**SECTION 00 90 03  
BIDDING AND CONTRACT REQUIREMENTS  
ADDENDUM NUMBER 3**

**Re: ADDENDUM NUMBER (3) TO THE BIDDING DOCUMENTS FOR**

**Student Farm Renovations  
Issued for Bid**

Architect's Project Number: 25-037

**2 ONE LINE DIAGRAM**  
 NO SCALE

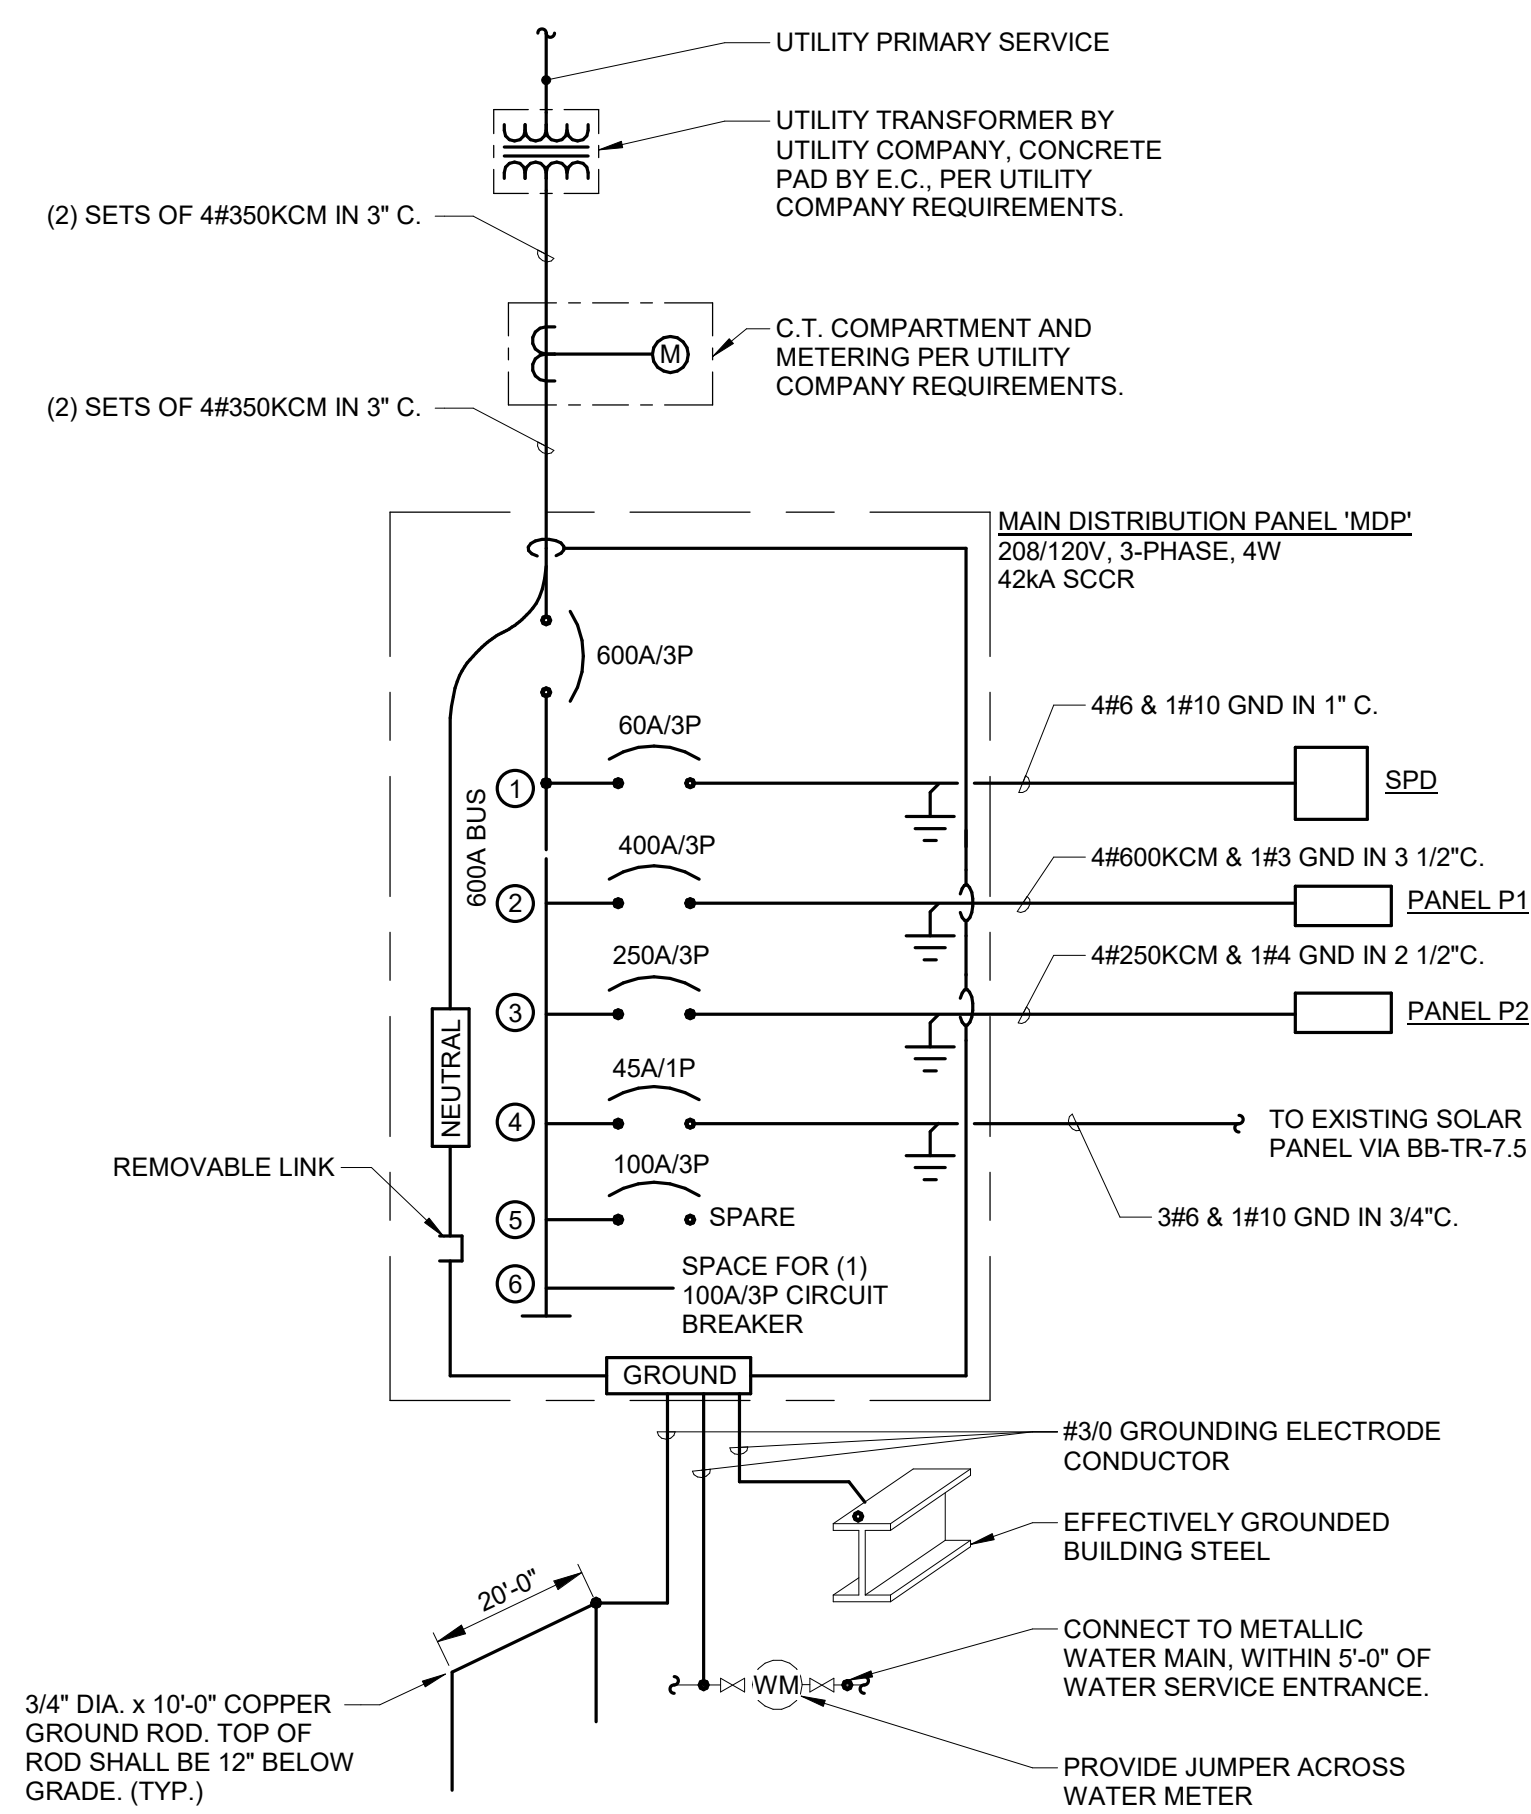
4. PRE-BID RFI #12: Is there a one line drawing available for this project? I do not see the drawings and there is also missing info for the MDP and the conduit runs. Please clarify

- A. **RESPONSE:** One-line diagram and all Main Distribution Panel 'MDP' information can be found on detail 2/E2.00.
5. PRE-BID RFI #13: Is there any wall tile on the project? I see most walls are FRP and none are showing tile. Please confirm.

SHEET NUMBER:  
**QF1.01**

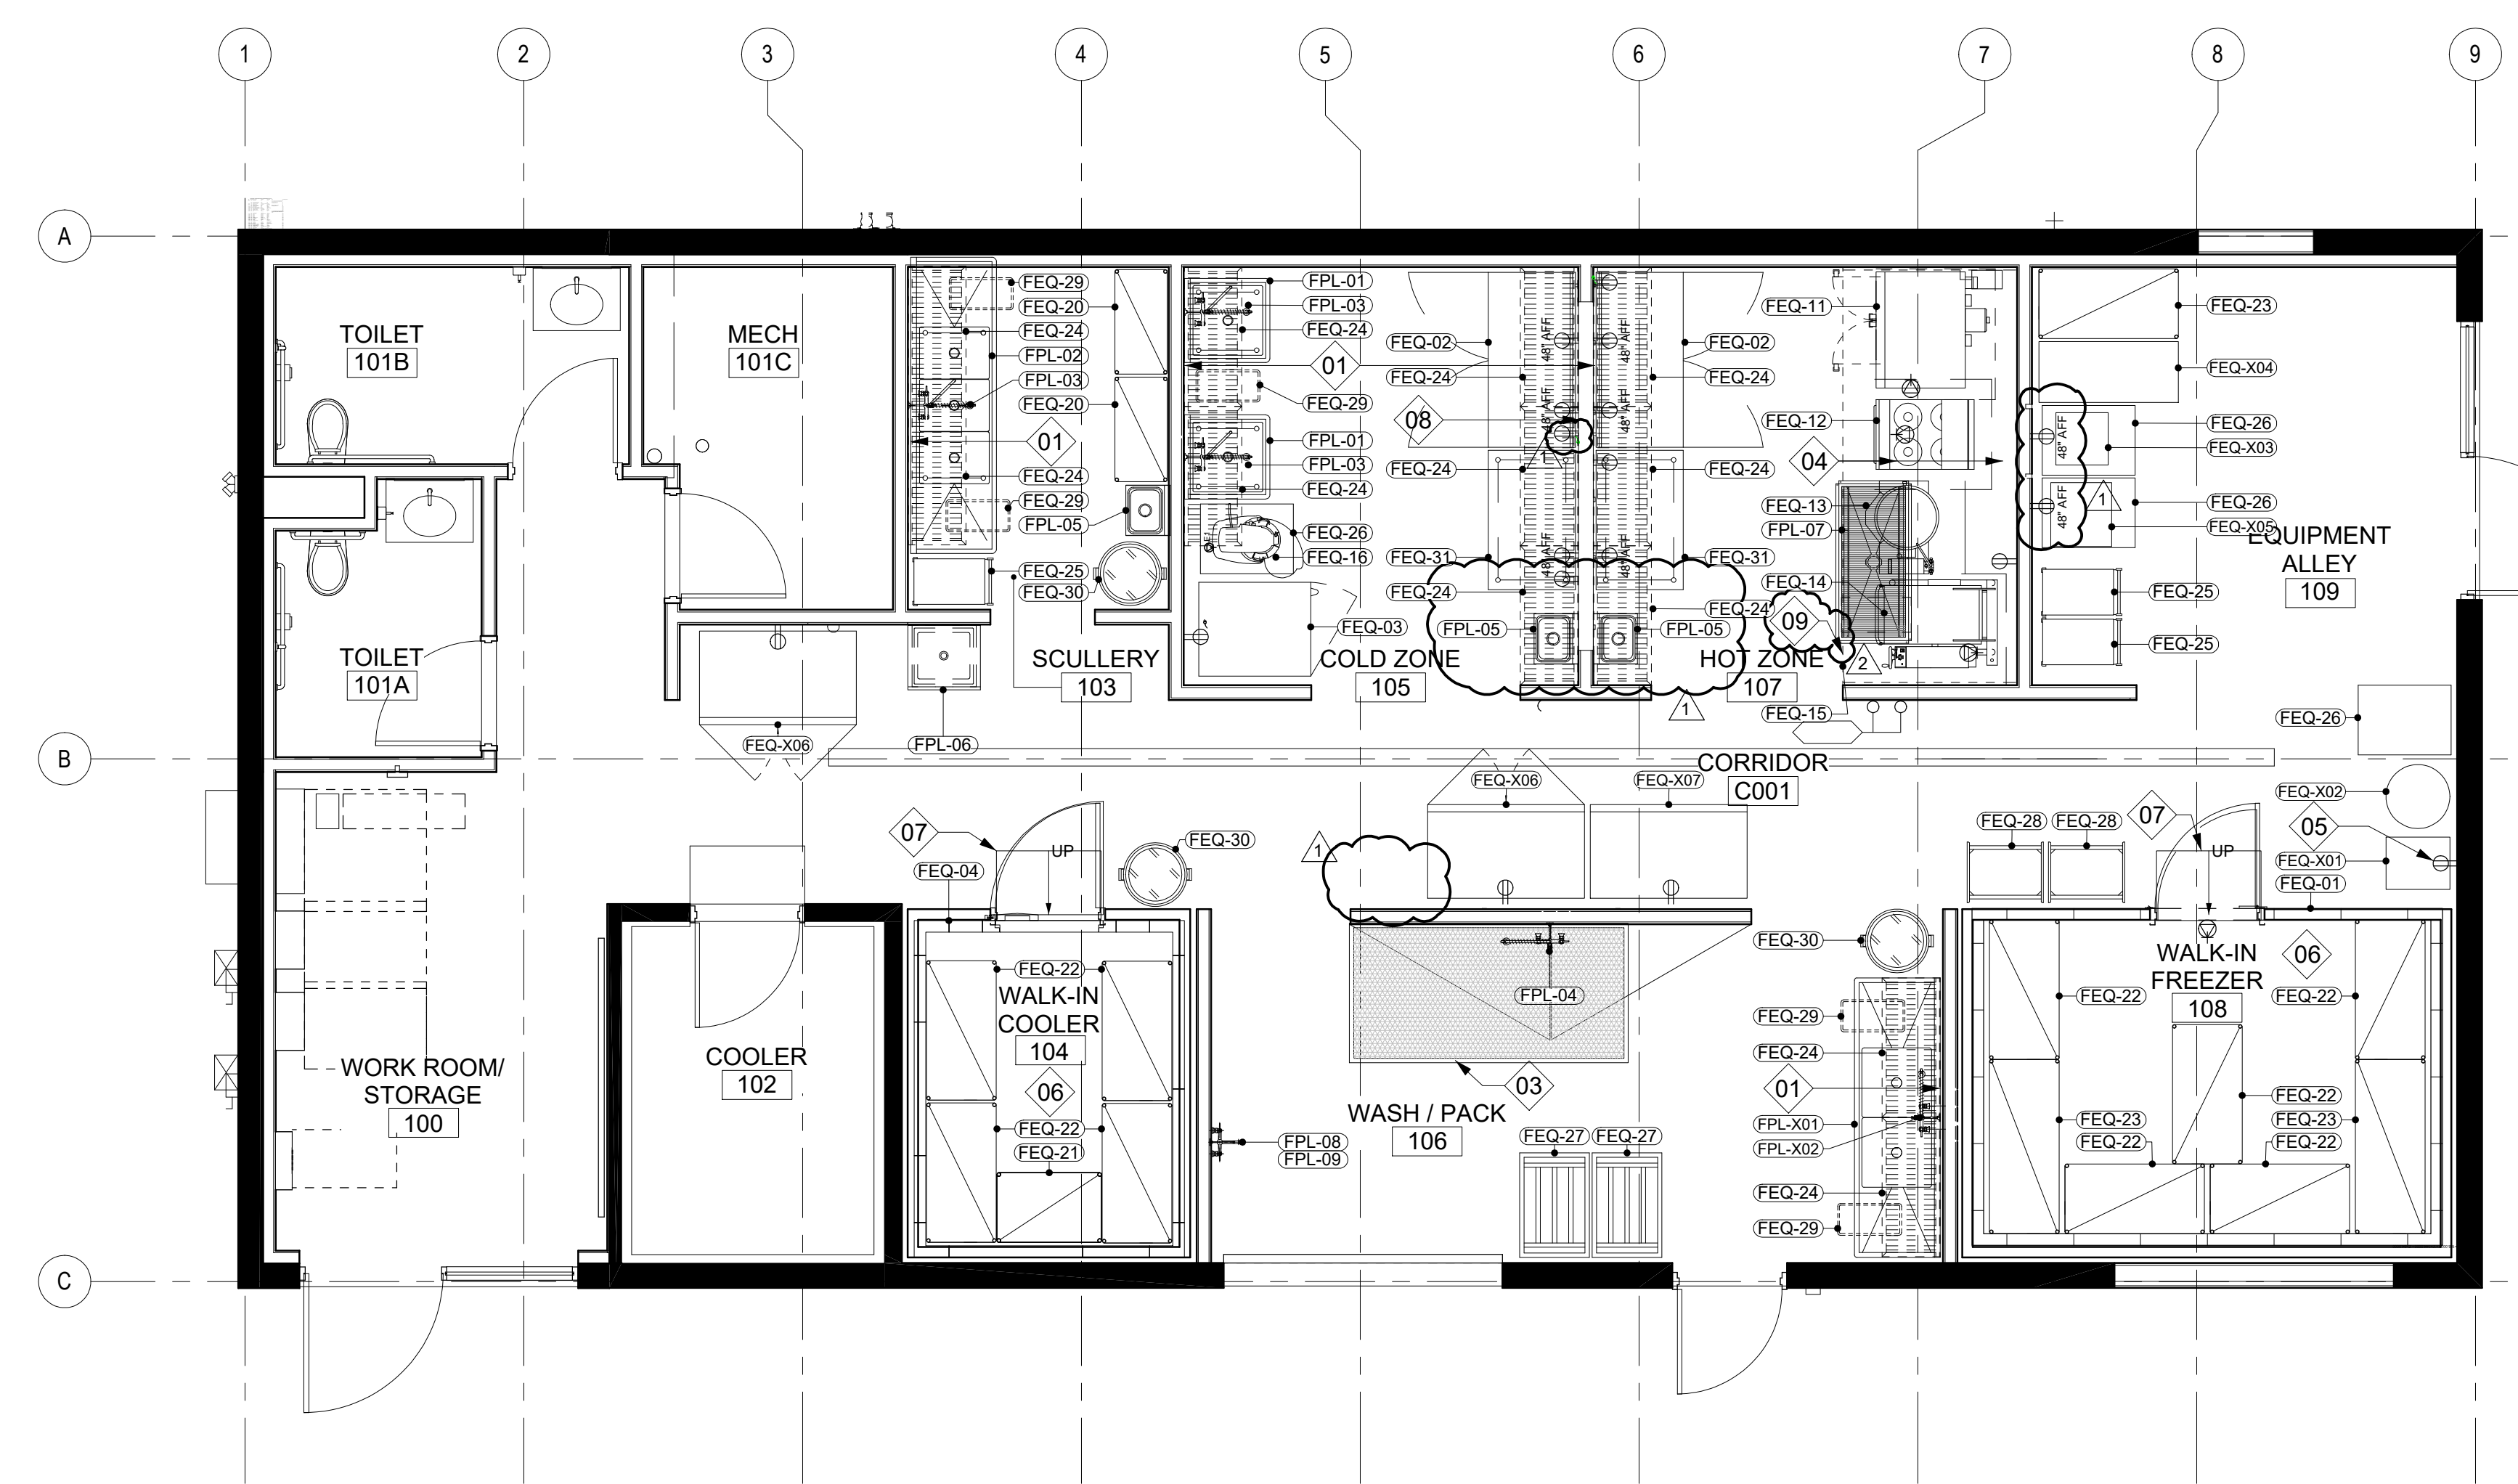
1. QF1.01
  - A. **REVISE** equipment schedule to include procurement responsibility as indicated.
  - B. **ADD** keynote 09 to keynote legend and equipment plan as indicated.
